Town of Ashland Planning Board
101 Main Street, 2nd Floor,
Ashland, MA 01721

May 11, 2016

**Subject: 0 Megunko Road
Site Plan Review Comments**

On behalf of the applicant (Ashland Landscape Supply, LLC), Connorstone Engineering, Inc, is transmitting revised plans and documentation for 0 Megunko Road. The enclosed plans and documents have been revised based peer review comments from PSC in a letter dated April 22, 2016. Specific responses to each of the review comments are provided below.

TURNING TEMPLATE EXHIBIT
 MEGUNKO ROAD
 ASHLAND, MA
 SCALE 1"=60'

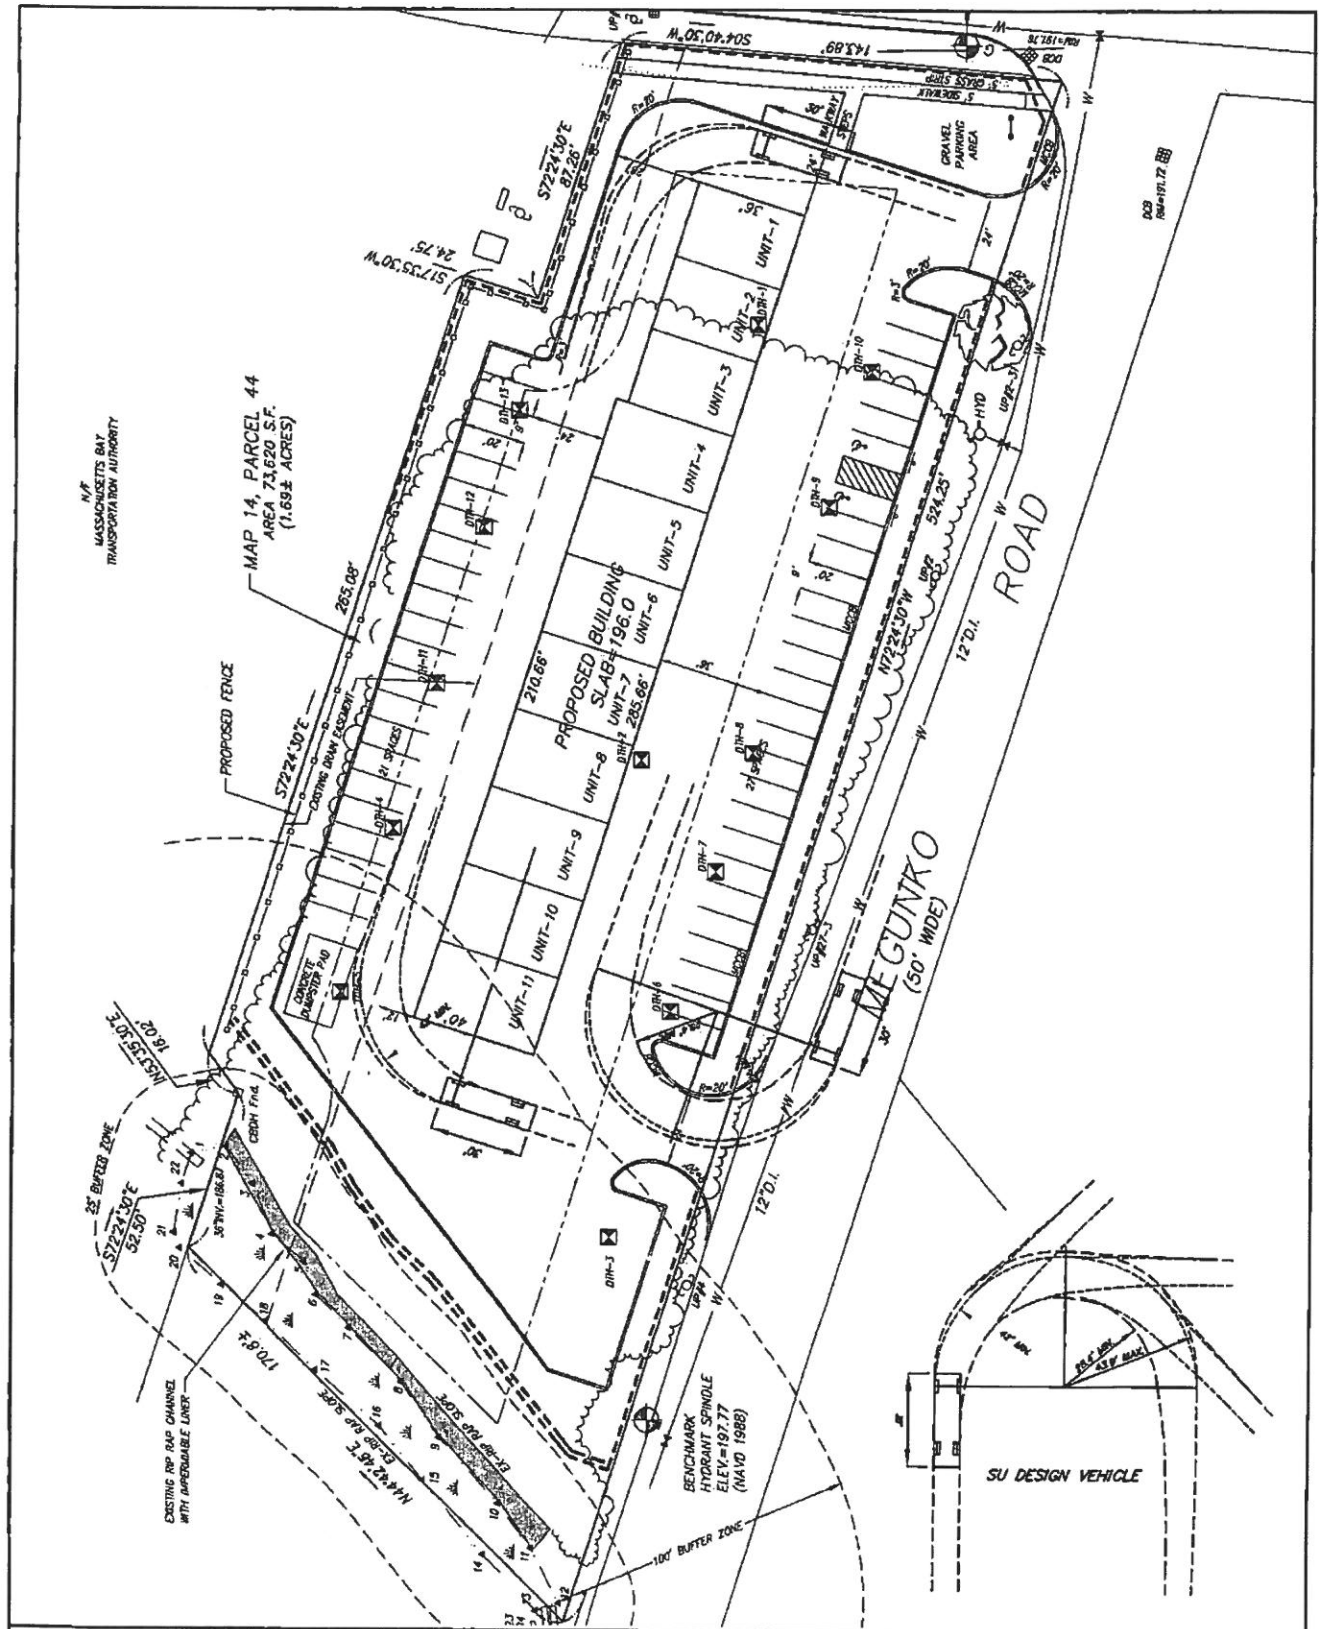
- P1. An turning analysis was previously submitted. A copy has been included with this letter.
- P2. Site landscaping to be reviewed by the Board.
- P3. The color, lettering, etc. of the sign would be reviewed by the Building Inspector.
- P4. Lighting has been reviewed and approved by the Design Review Board.
- P5. Item Addressed.
- P6. Updated Architectural Plans to be provided to the Board by the Owner.

Figure 7-5. (T2) MINIMUM TURNING PATH FOR WB-12 DESIGN VEHICLE.

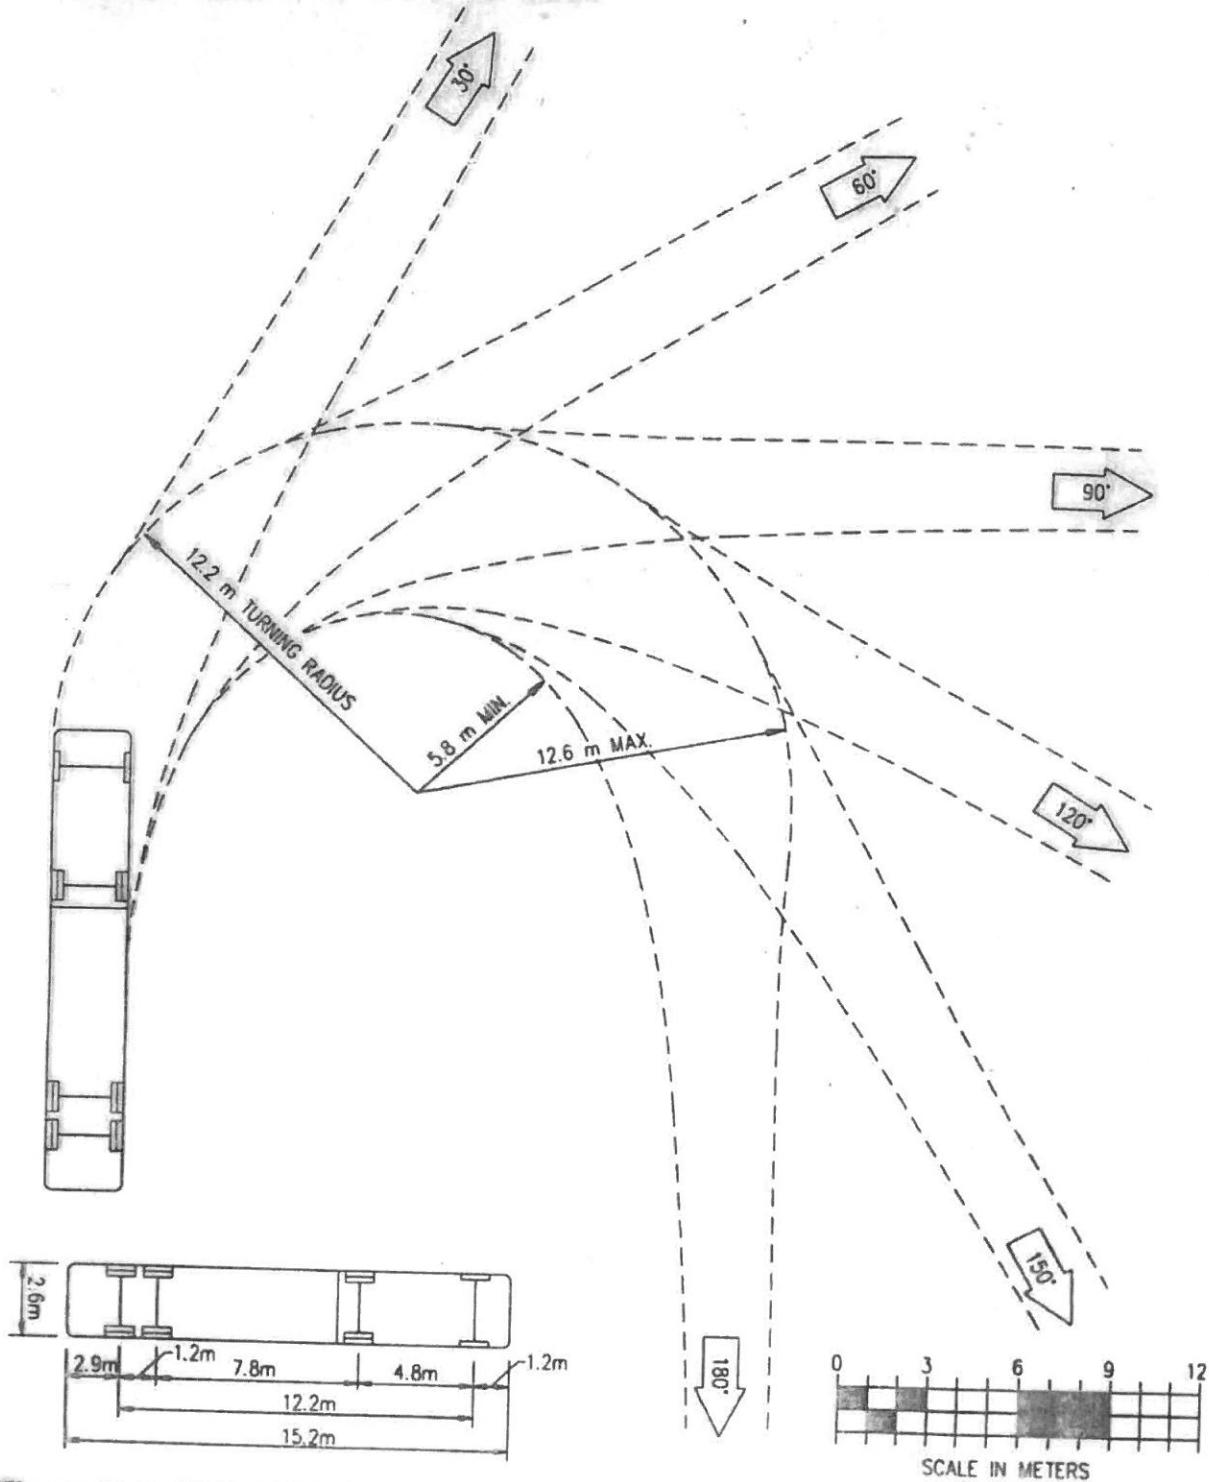
Item P1 – The comment has requested the use of a WB-40 vehicle rather than a SU vehicle. A WB-40 vehicle has a smaller turning radius than a SU vehicle and is less restrictive in the design. The attached sketch shows the requested WB-40 vehicle with adequate circulation throughout the site.

Megunko Road, Ashland
Mounding Analysis 5/23/16

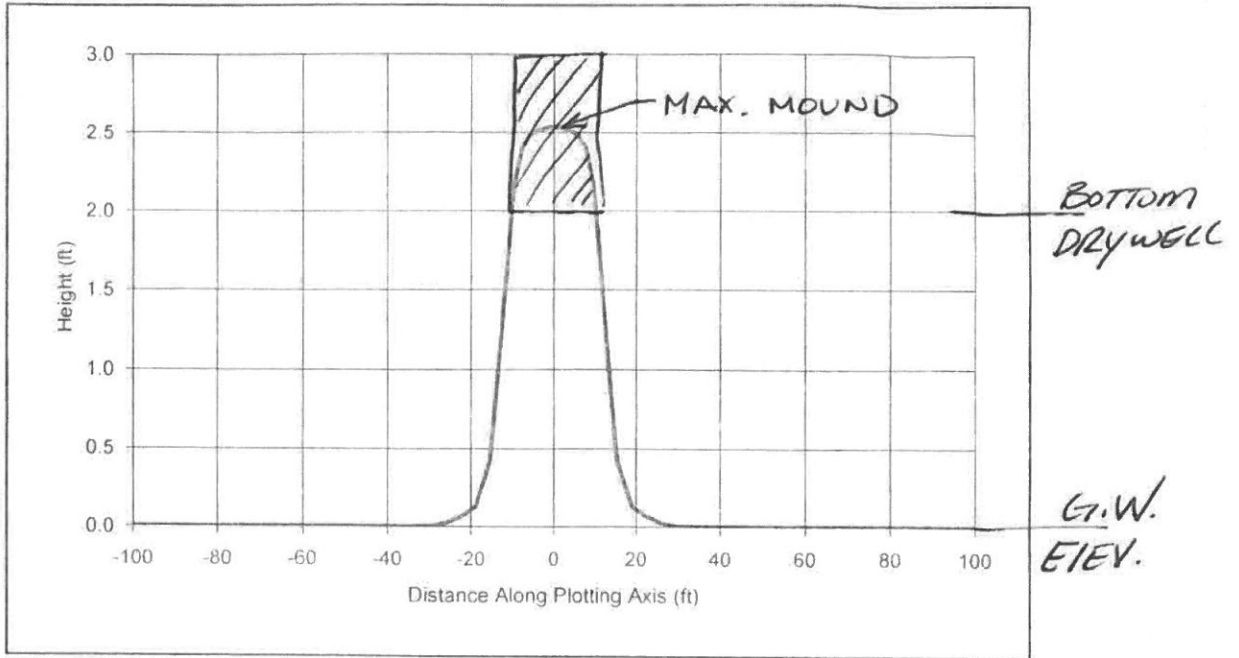
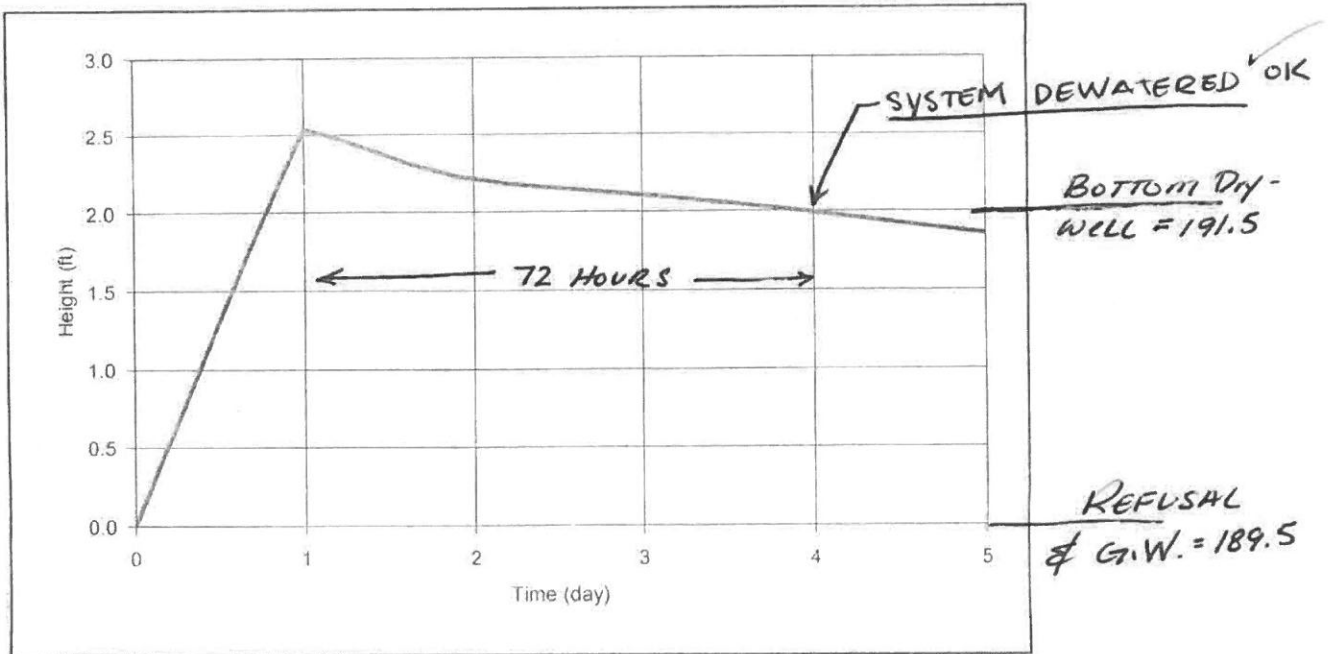
Item SW1 – The comment had requested a revised mounding analysis to account for refusal noted in the center test pits. This appeared to be a boulder in the bottom of the holes that could be removed with a larger machine, and was localized in that area. However, a revised mounding analysis has been attached assuming the entire bottom of the drywell had bedrock two feet below the system. The results verify the system would be dewatered within 72 hours after the storm.
